Product hierarchy no. *	Part no.	SBU	Type / Description	Customer part no.
04 019 XXX XXXXXXXXXXXX	4430.XXXX	Protection	TA45

2 Type of change

Shift of production location.

TA45					0118.2228	
creation date	created by	release date	released by	notification no.	revision	page
2014-07-17	buholzma	2014-08-07	buholzma	26428	a	1 of 2

Changes for 2-pole TA45:

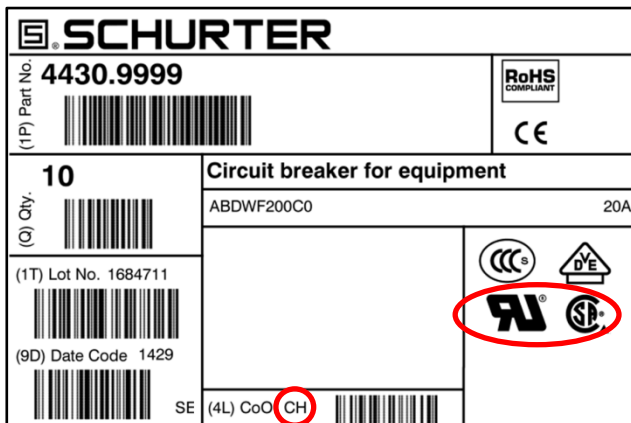
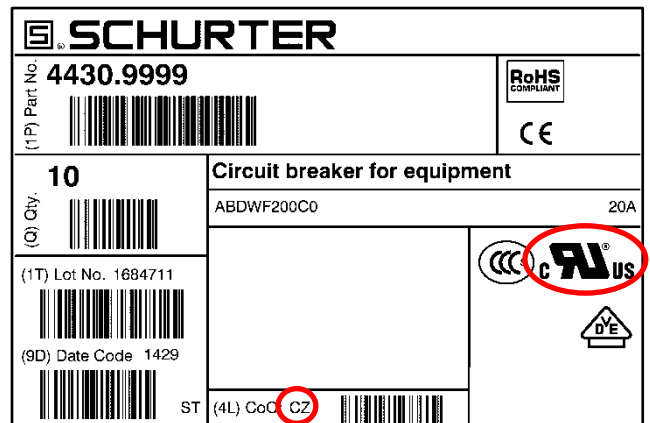
- Change 1: Production relocation from Switzerland to Czech Republic. New Country of Origin (CoO). All TA45 are affected from this change.
- Change 2: Czech product location has combined  mark instead of  and . All 2-pole TA45 are affected from this change. 3-pole types don't have  and  approvals.

Old packing label:

New packing label:

Form: None
Fit: None
Function: None
Production Site: Yes, Country of Origin (CoO) changes from CH to CZ.
Product Label: Country of Origin (CoO) changes from Switzerland (CH) to Czech Republic (CZ).
New approval mark instead of and on all labels for 2-pole types.

Change for 3-pole TA45:

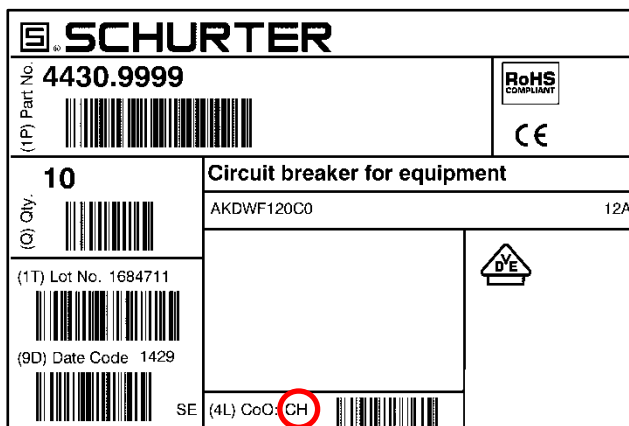
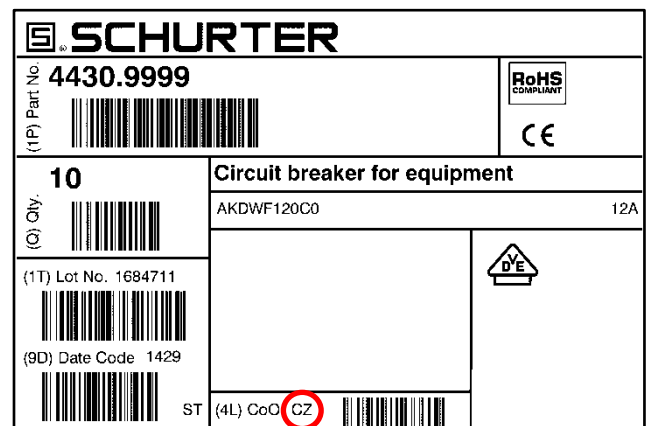
Old packing label:

New packing label:
